EEG Review Comments on the Geotechnical Reports Provided by DOE  
to EEG Under the Stipulated Agreement Through March 1, 1983

Environmental Evaluation Group  
Environmental Improvement Division  
Health and Environment Department  
P.O. Box 968  
Santa Fe, New Mexico

April 1983

Figure 1. Structure Contours on Top of Culebra

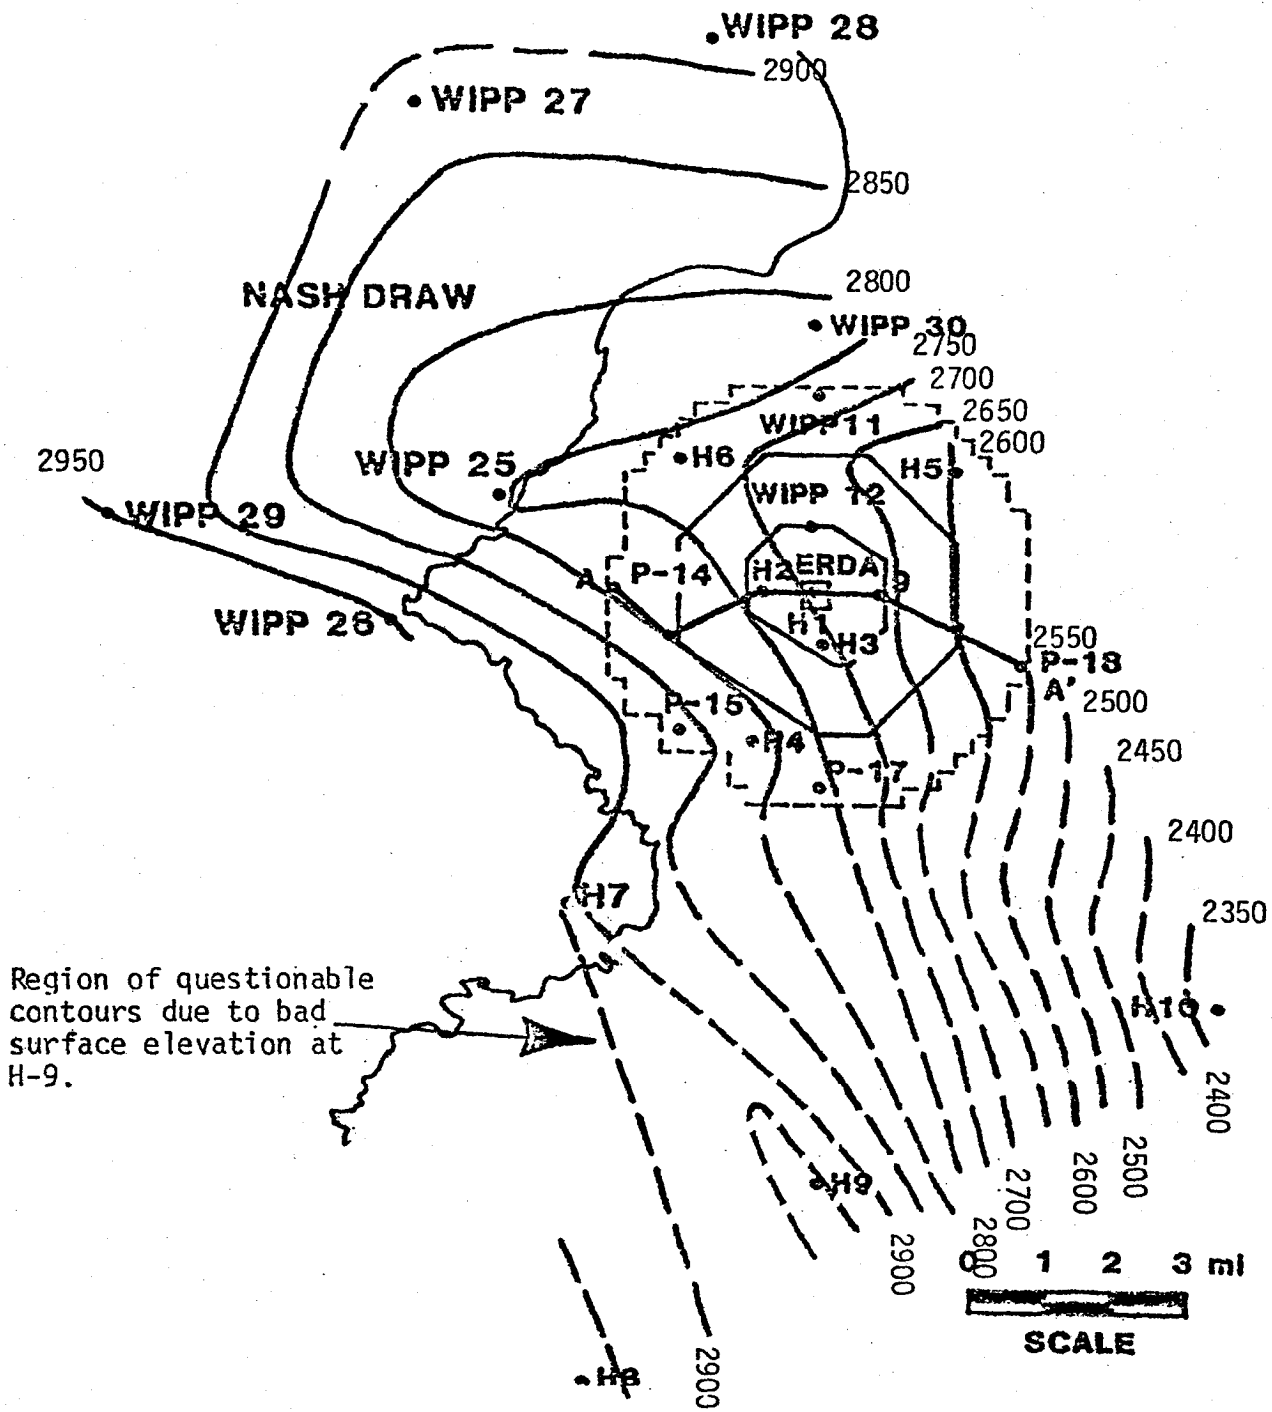
- b. A structure contour map (see Figure 1) on top of the Culebra was generated from Table 1 of the report. It indicates a depression extending through the WIPP-25, H-6, H-5 area. This depression may be associated with a karst channel.

- b. A structure contour map (see Figure 1) on top of the Culebra was generated from Table 1 of the report. It indicates a depression extending through the WIPP-25, H-6, H-5 area. This depression may be associated with a karst channel.

Figure 2. Fresh Water Altitude Contours for Culebra

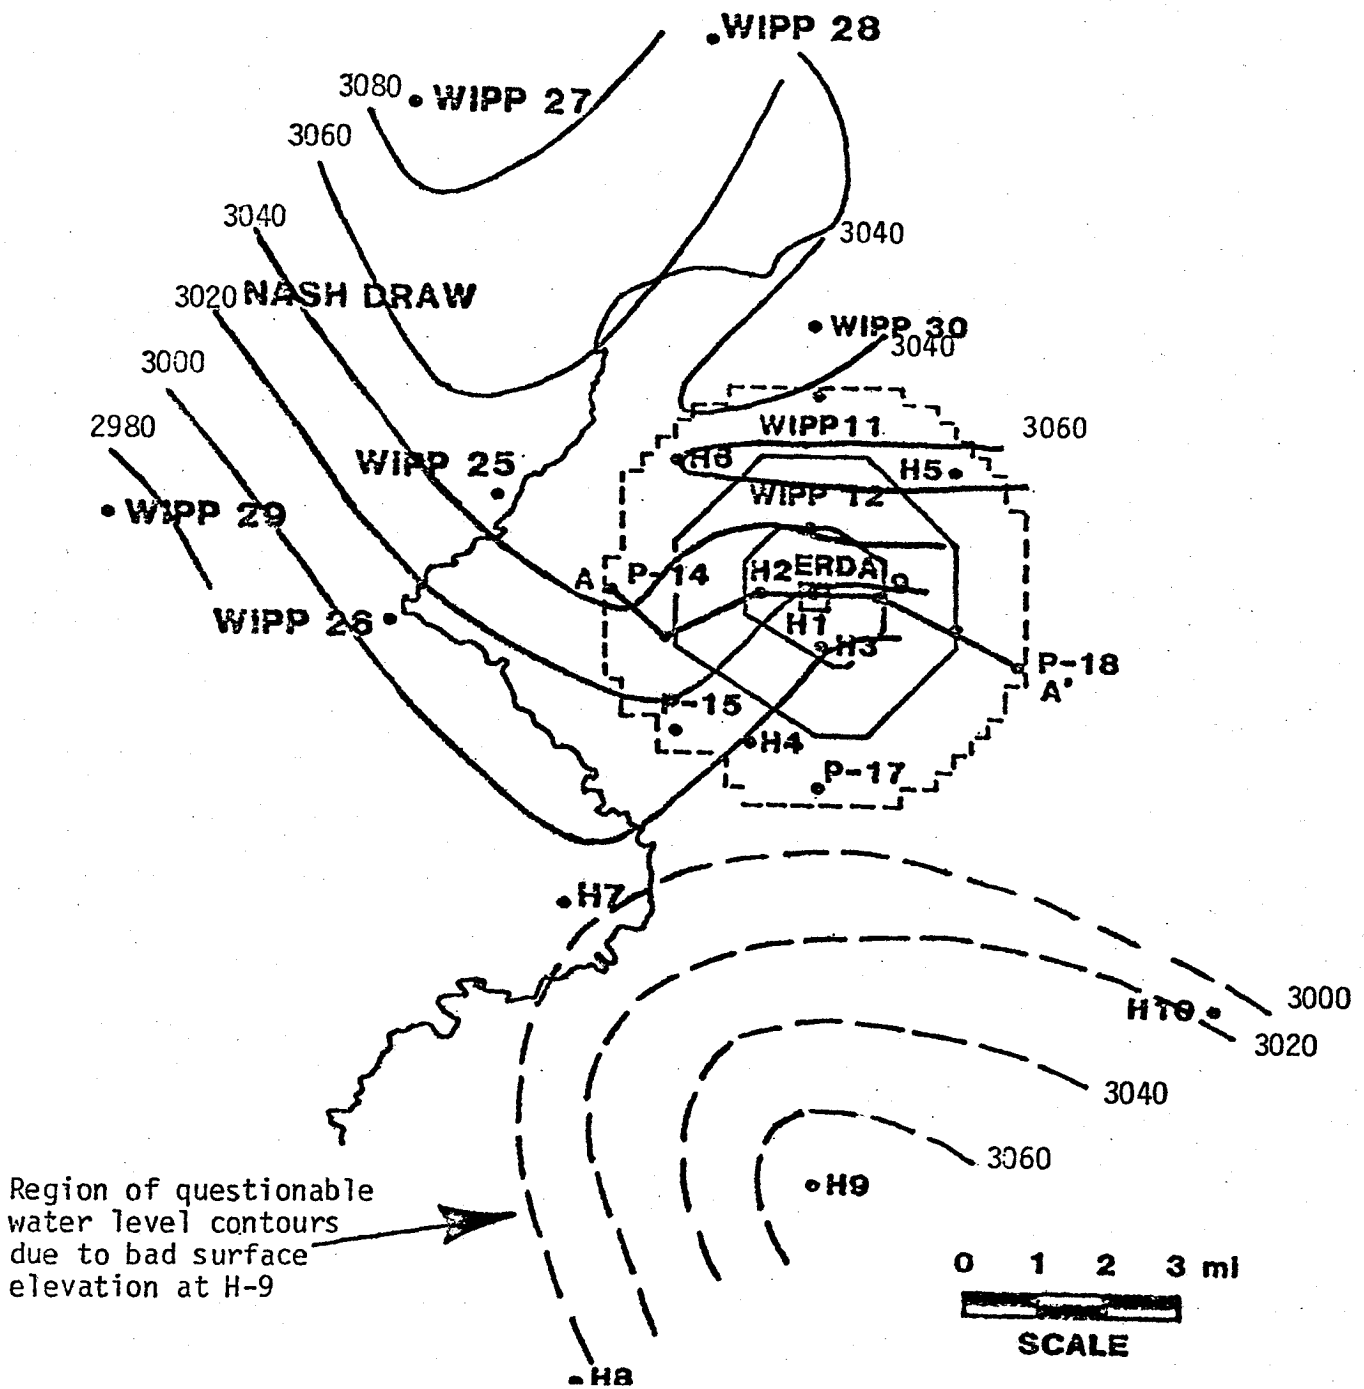
- c. A fresh water altitude map (see Figure 2) for the Culebra was constructed from the data presented in Table 1 of the report. The figure indicates that a ground water high is associated with the depression. The ground water high indicates a potential for some flow to the west. If possible the review of the aerial photographs should extend from the northern part of Nash Draw to Malaga Bend.

- c. A fresh water altitude map (see Figure 2) for the Culebra was constructed from the data presented in Table 1 of the report. The figure indicates that a ground water high is associated with the depression. The ground water high indicates a potential for some flow to the west.
